ADDENDUM NO. 3

TO: PLANS AND SPECIFICATIONS FOR STATE OF MISSOURI

**USB Roof Replacement & Latrine Renovation
Chillicothe Readiness Center
1500 Washington St.
Chillicothe, Missouri 64601
PROJECT NO.: T2519-01**

September 2, 2026

SHEET NUMBER:

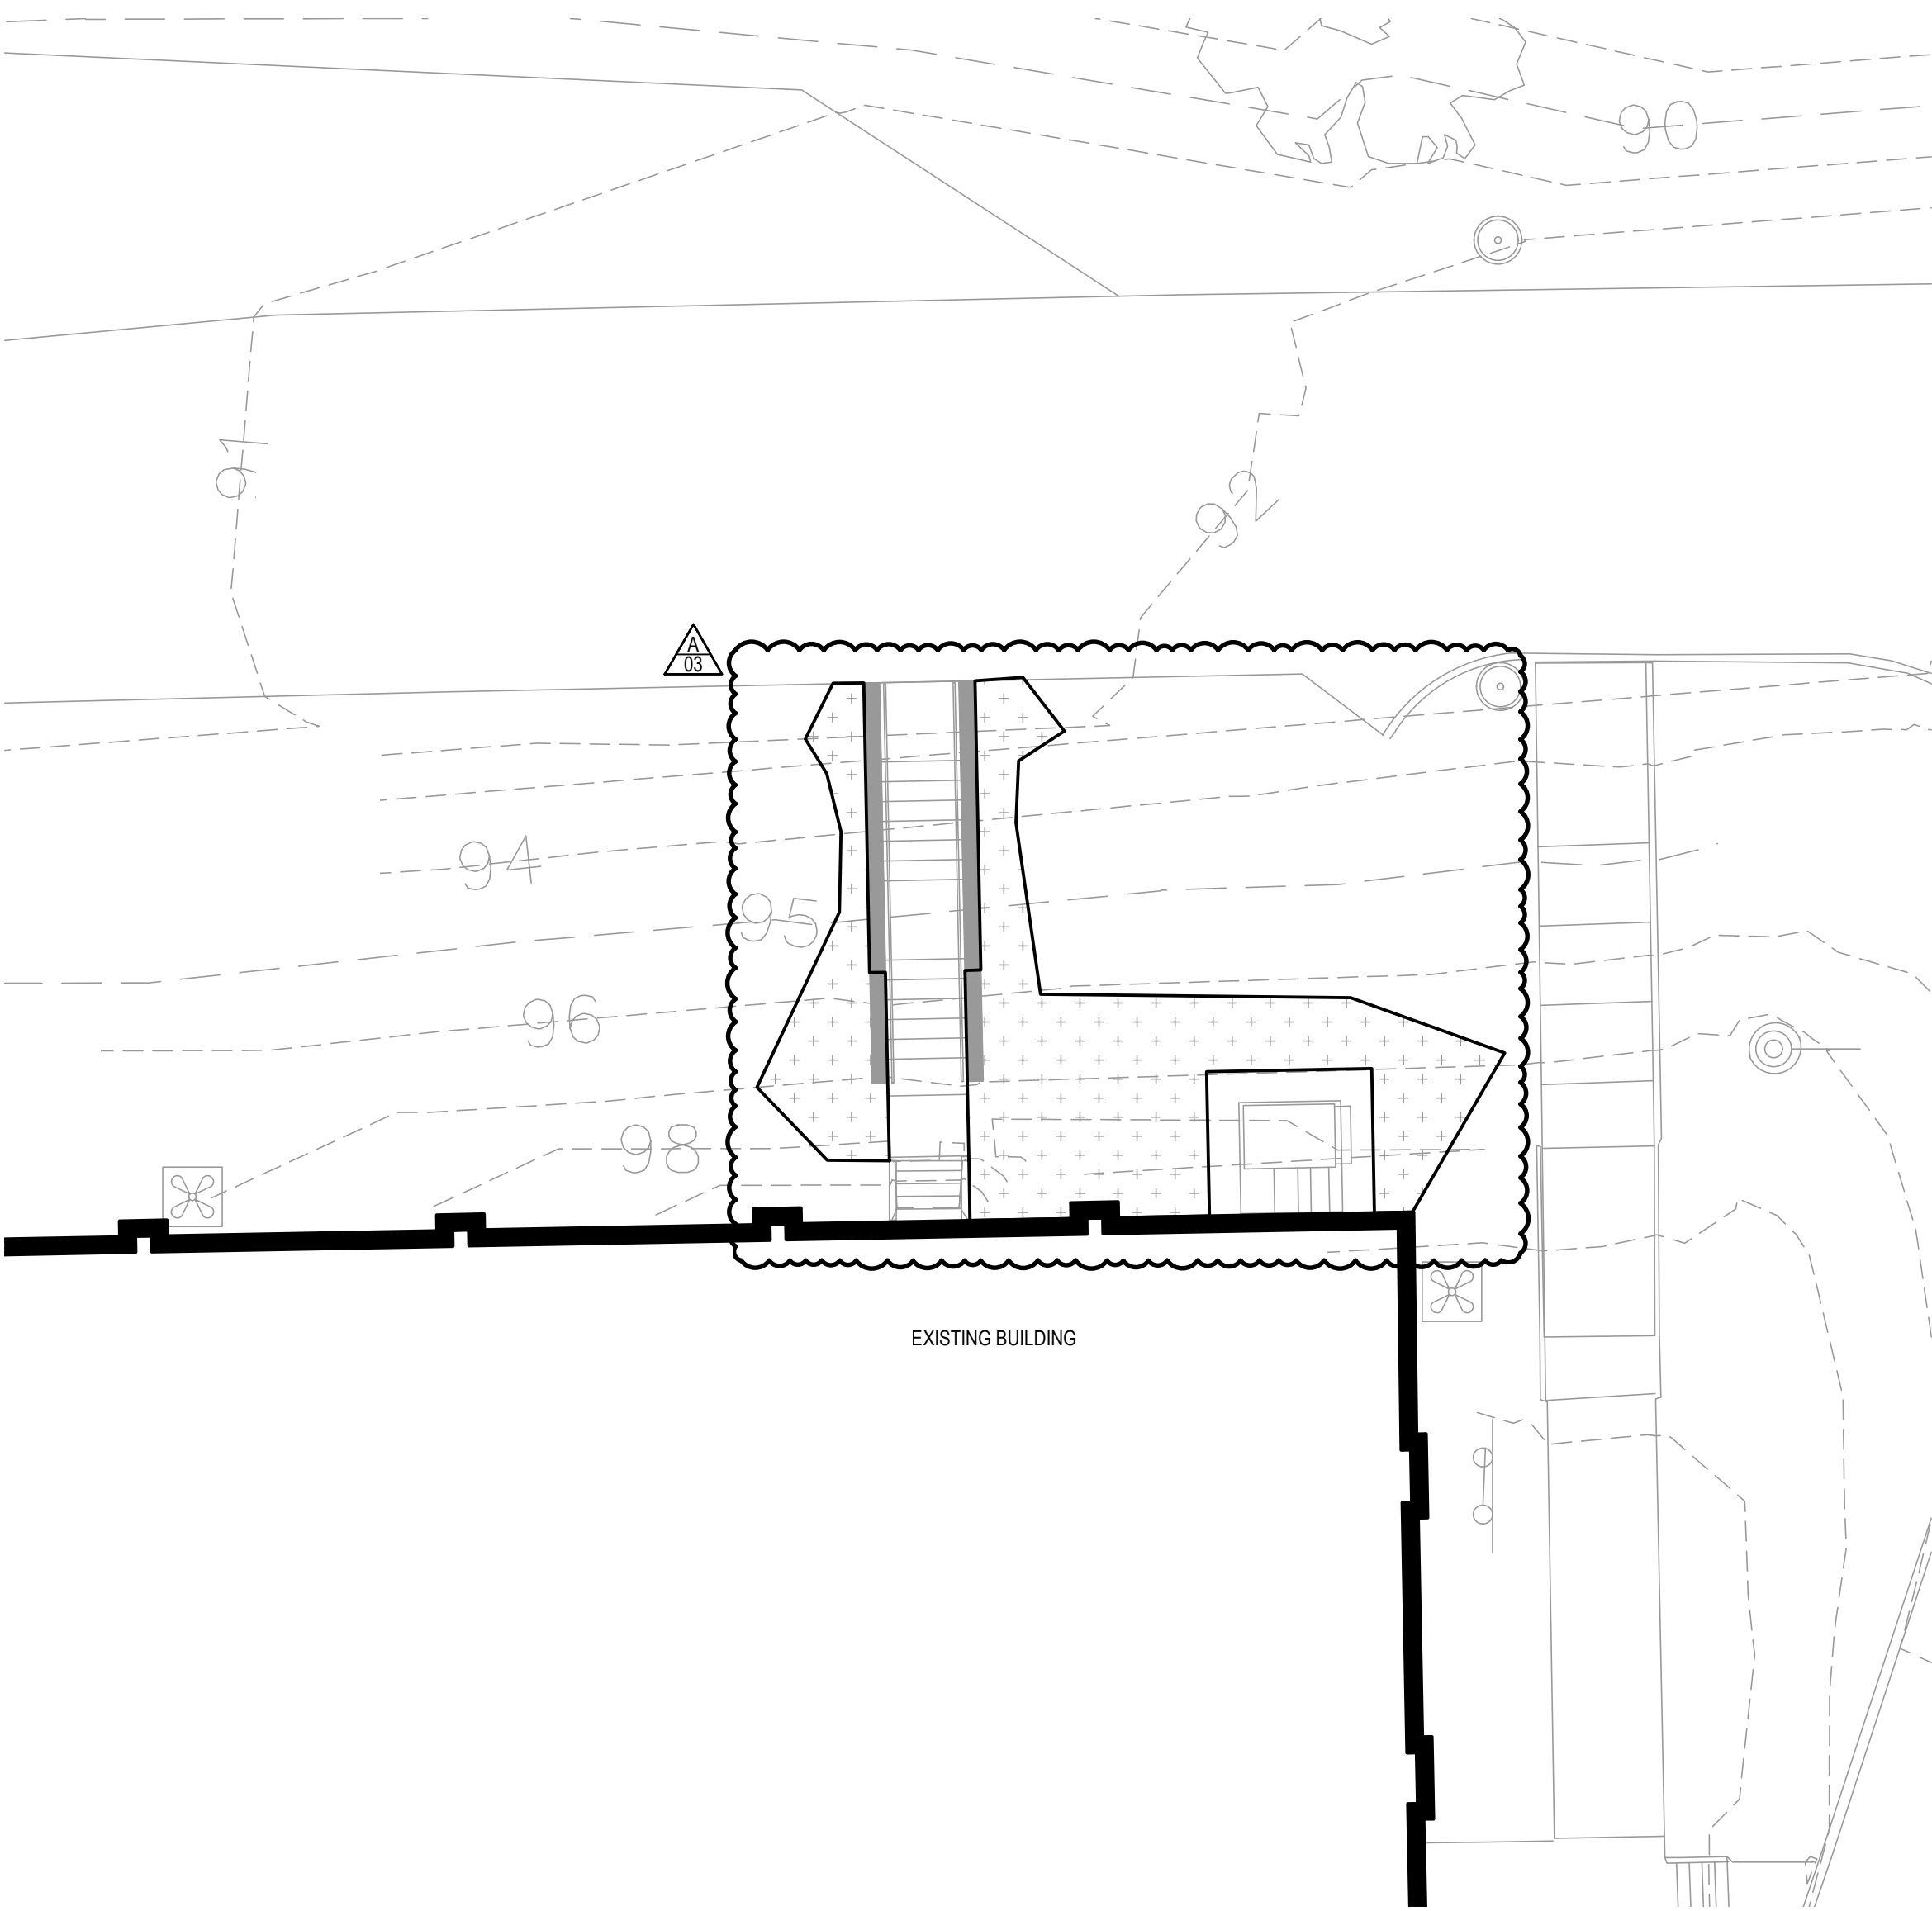
1. Sheet L-101 – Existing Conditions and Demolition Plan
 - a. ADDED demolition of existing north stair landing.
2. Sheet L-201 – Site Layout Plans
 - a. REVISED site conditions.
3. Sheet L-301 – Site Grading Plans
 - a. REVISED site conditions.

SHEET TITLE:
SITE SEEDING PLANS

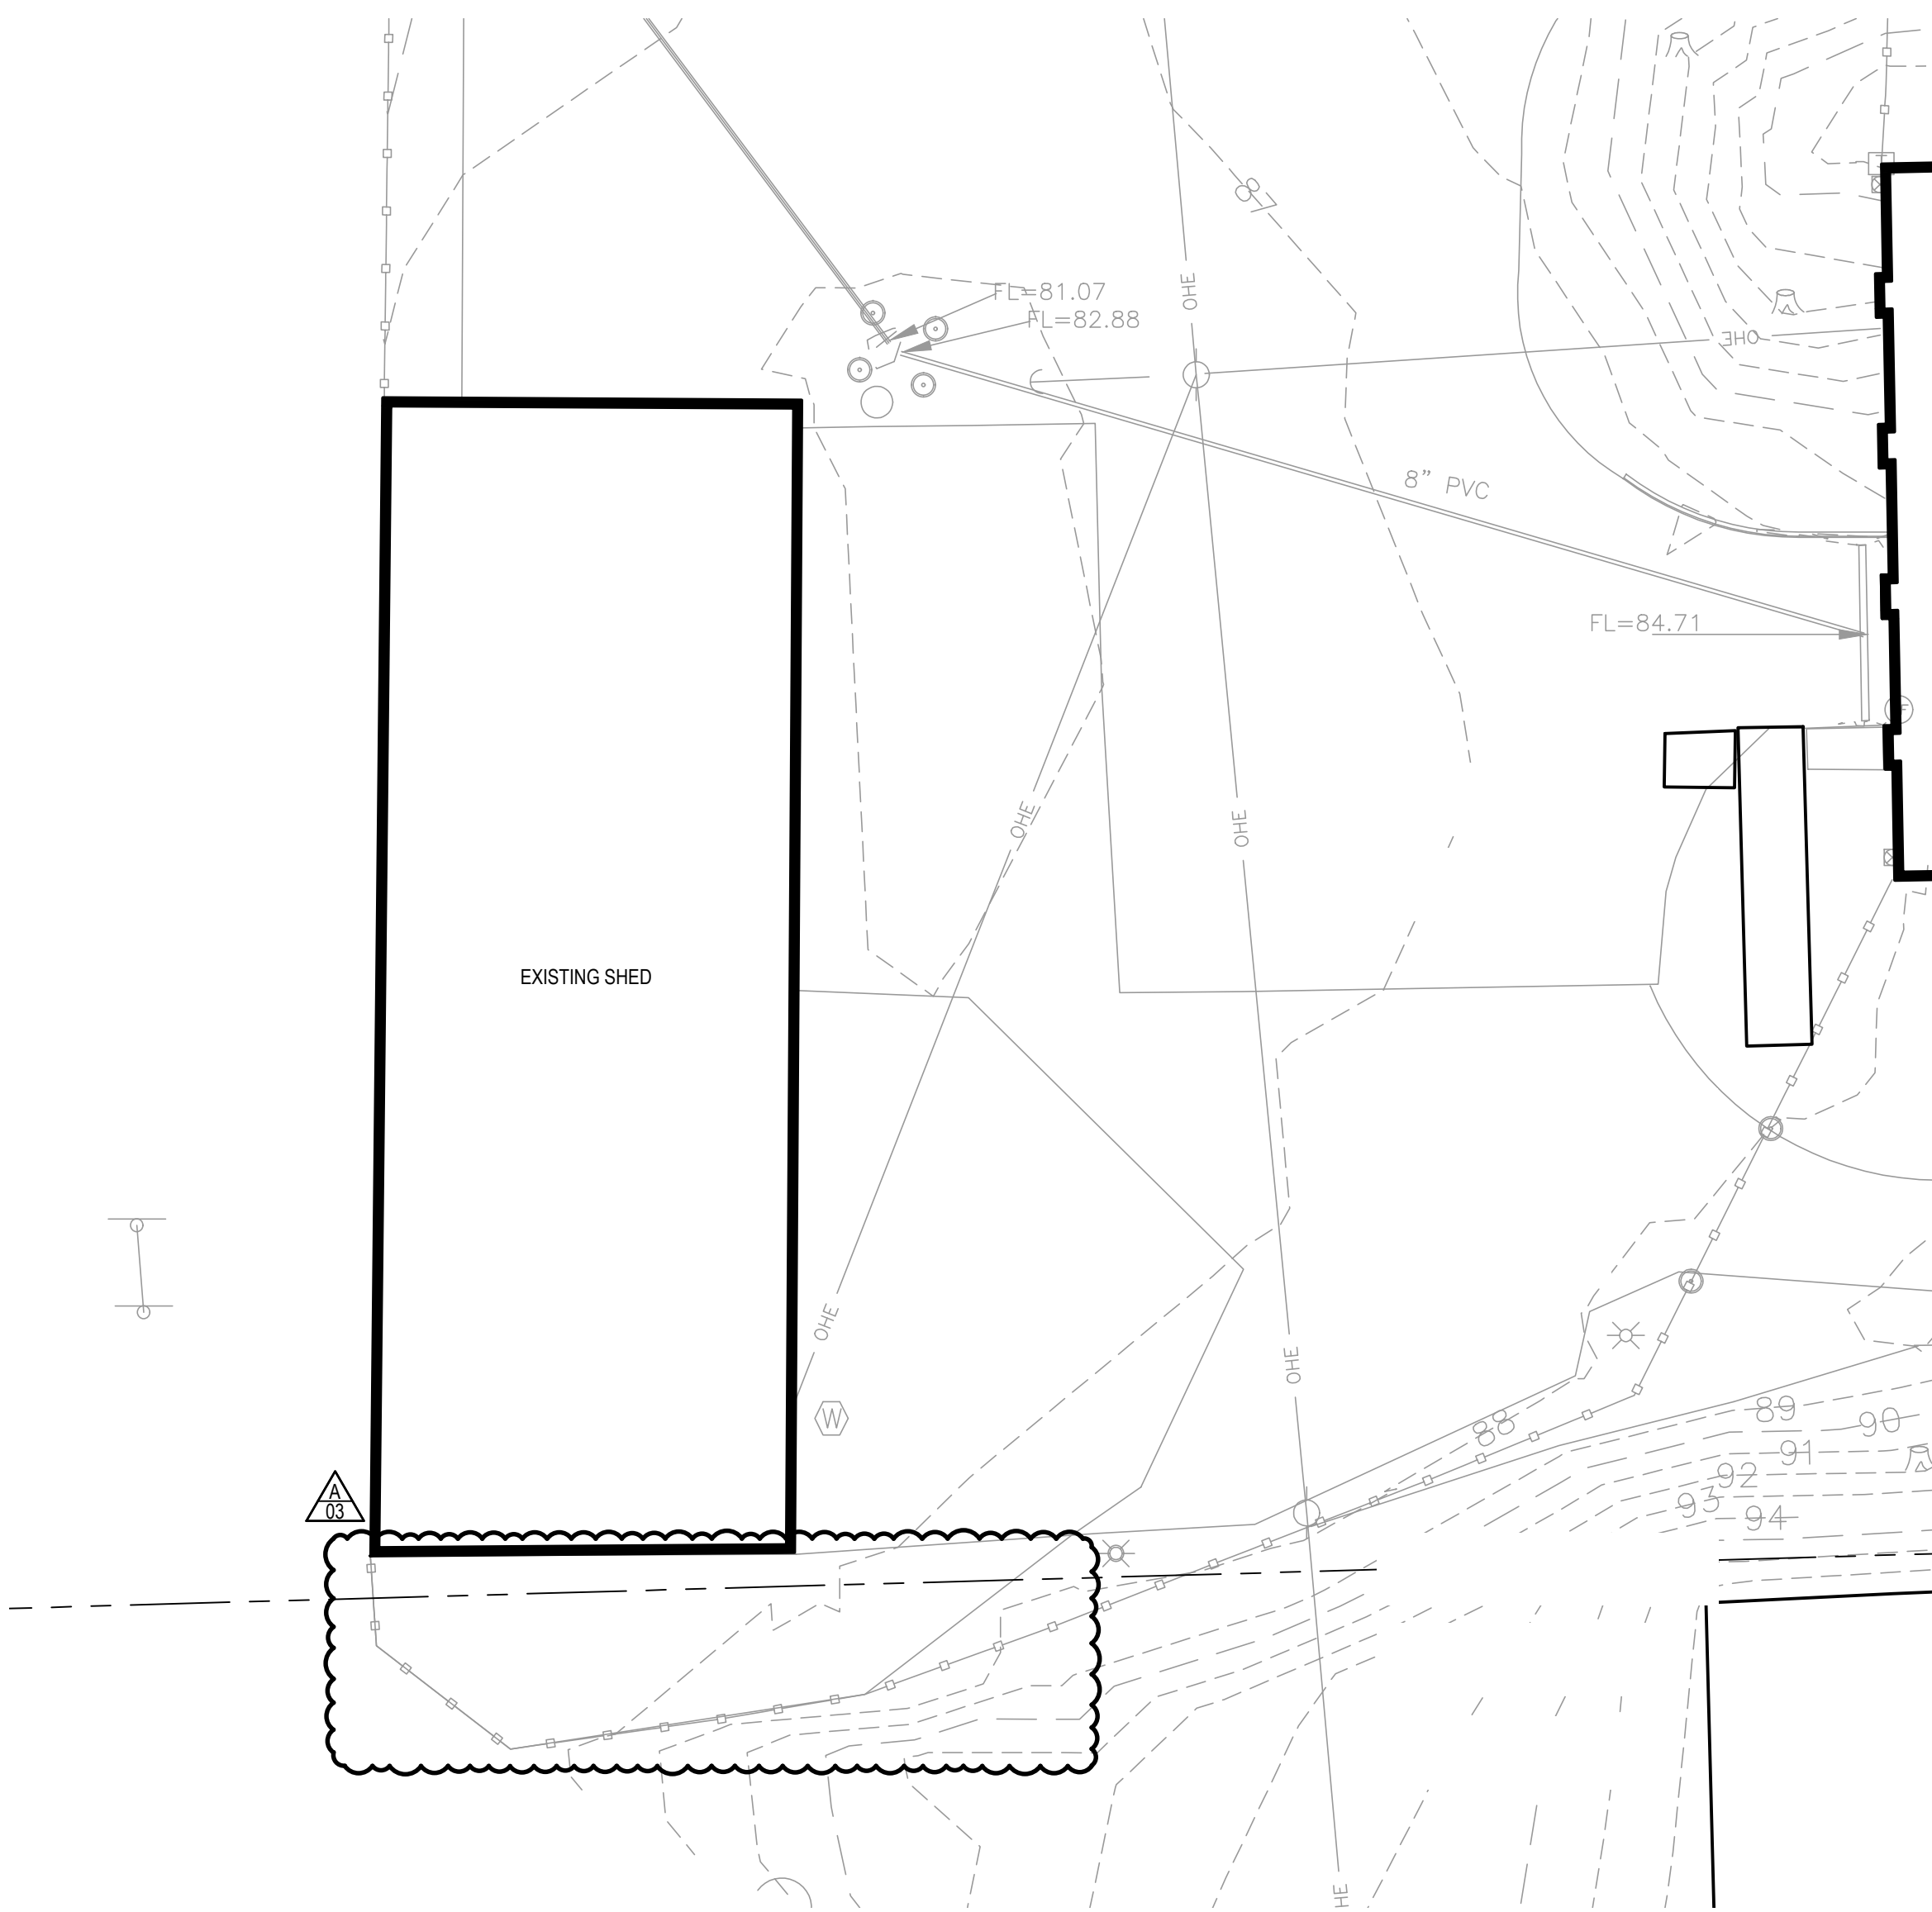
4. Sheet L-401 – Site Seeding Plans

- a. REVISED seeding locations on site.

SHEET TITLE:
SITE DETAILS

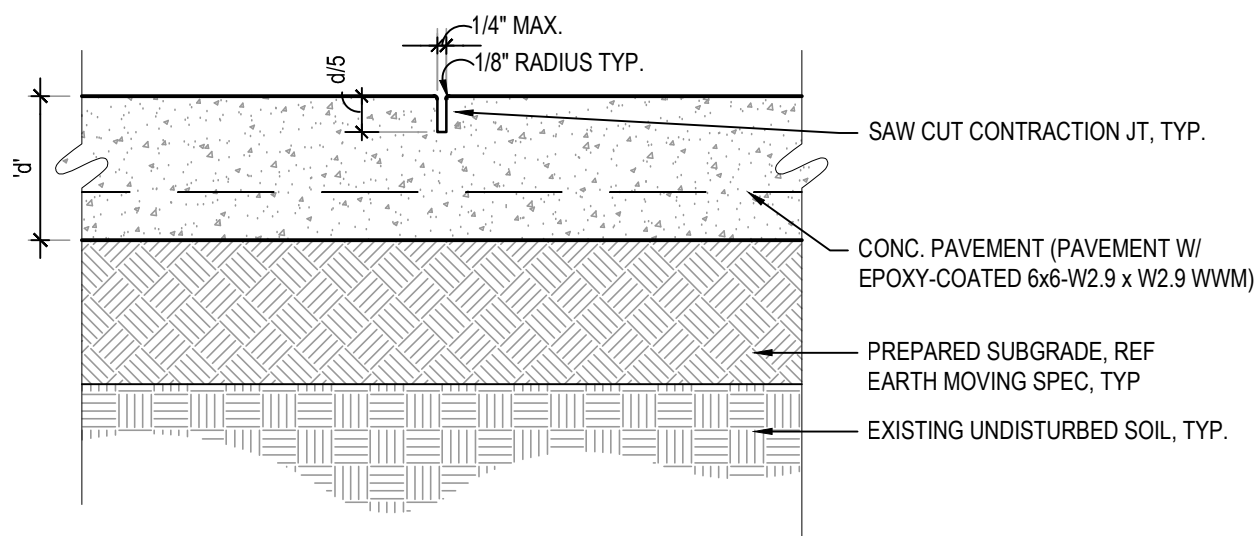
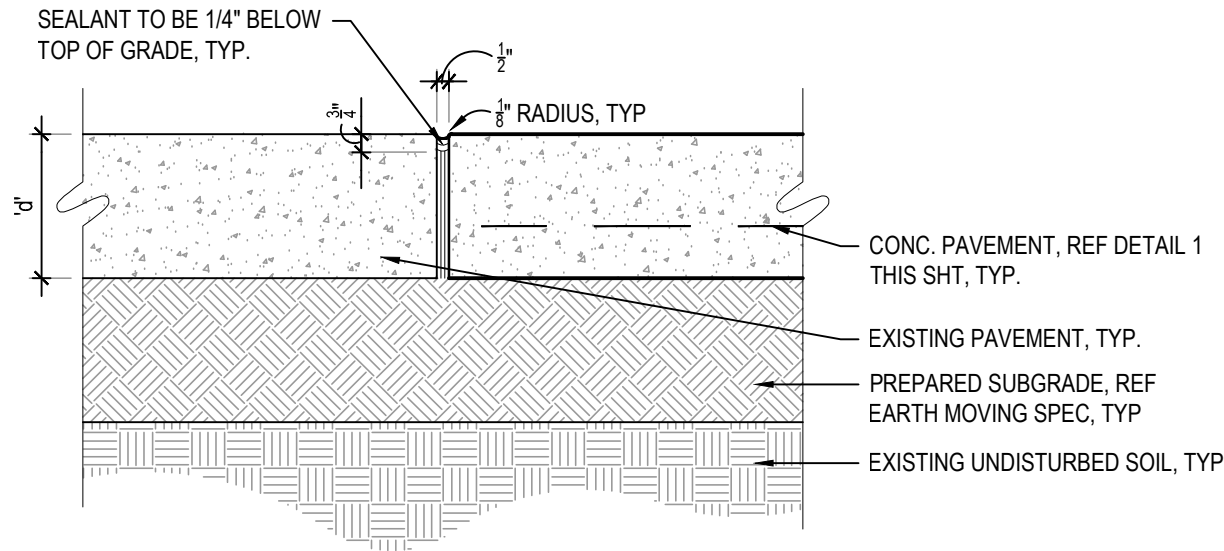
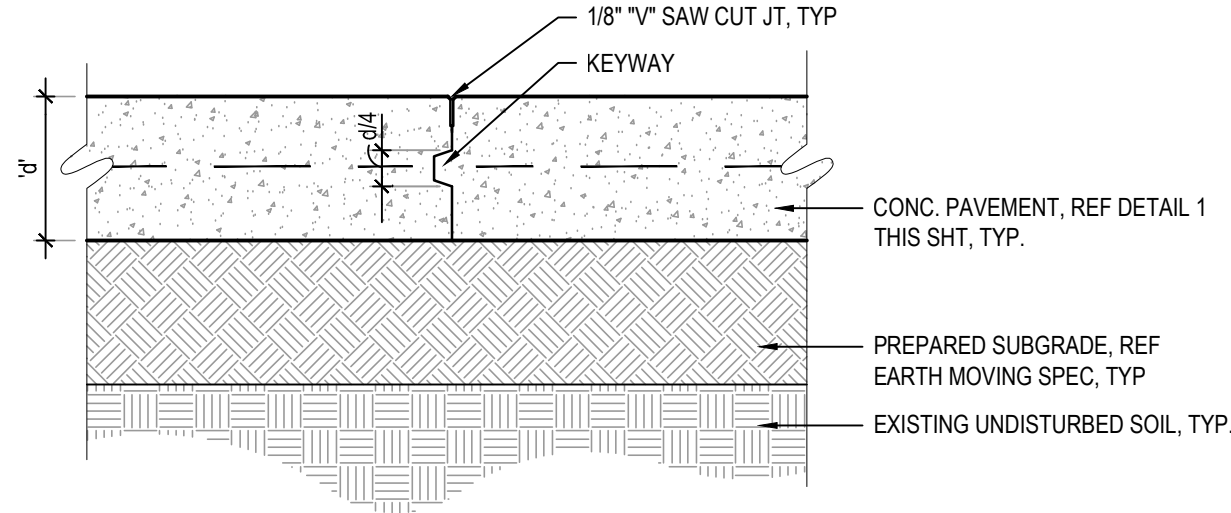
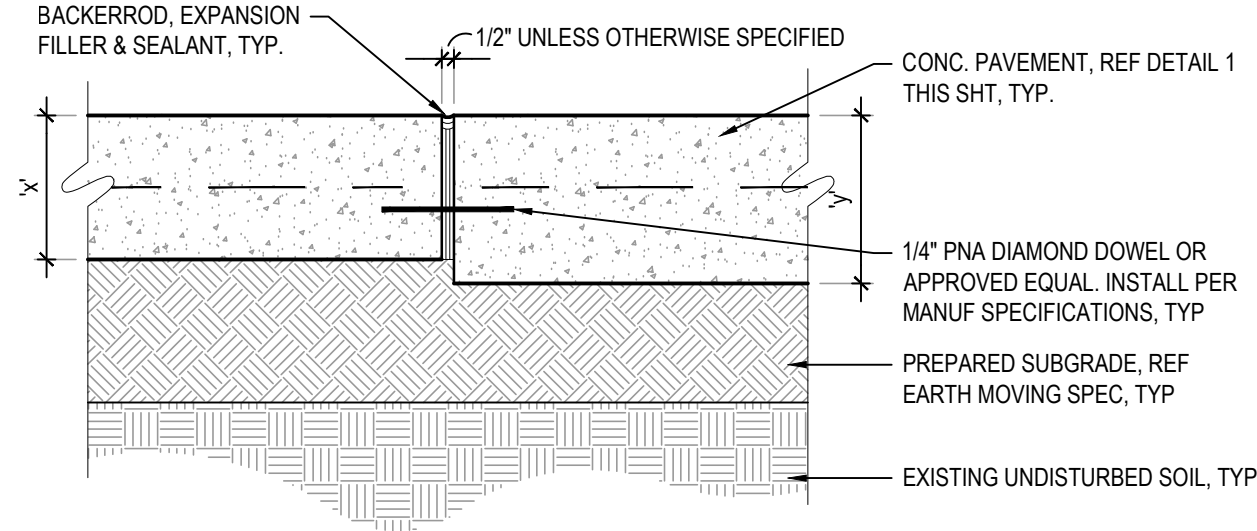
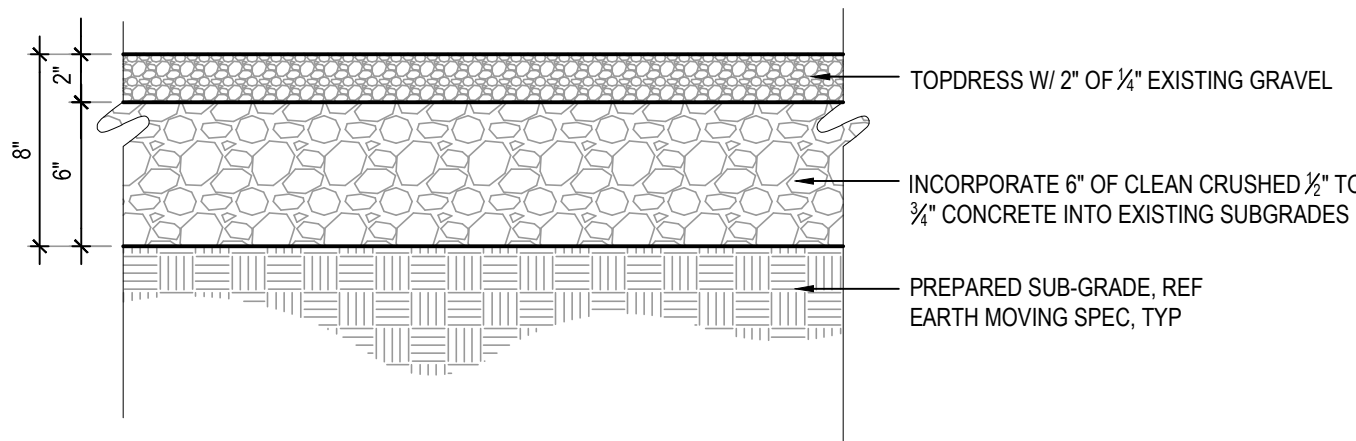
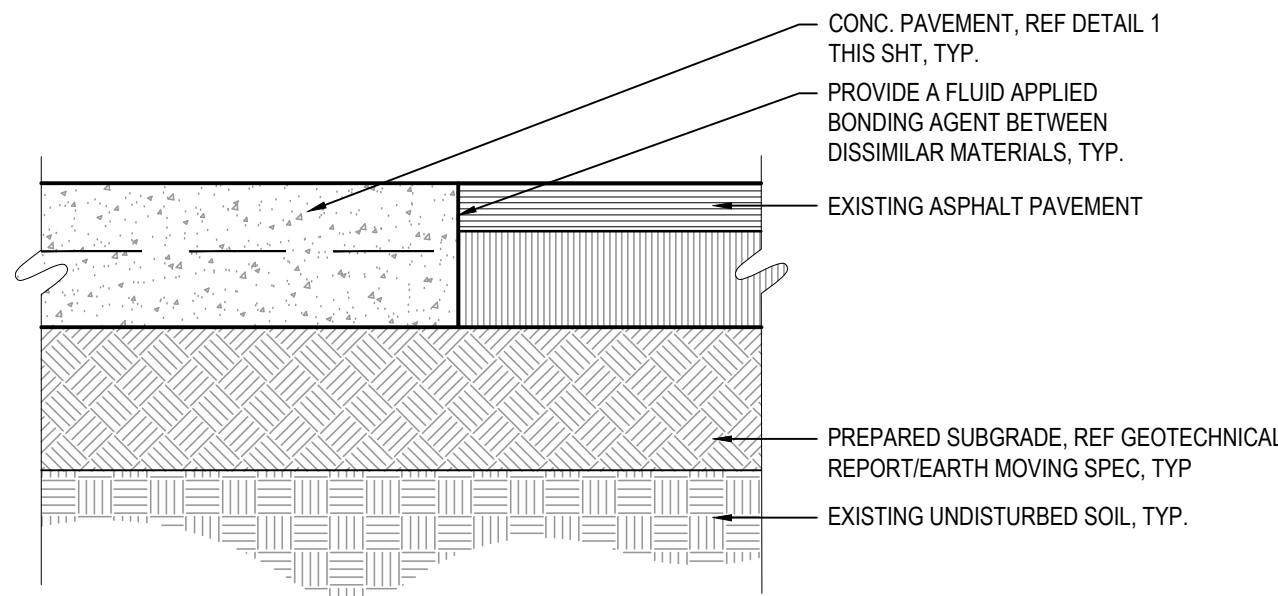
5. Sheet L-501 – Site Details

- a. REVISED location of stair details.
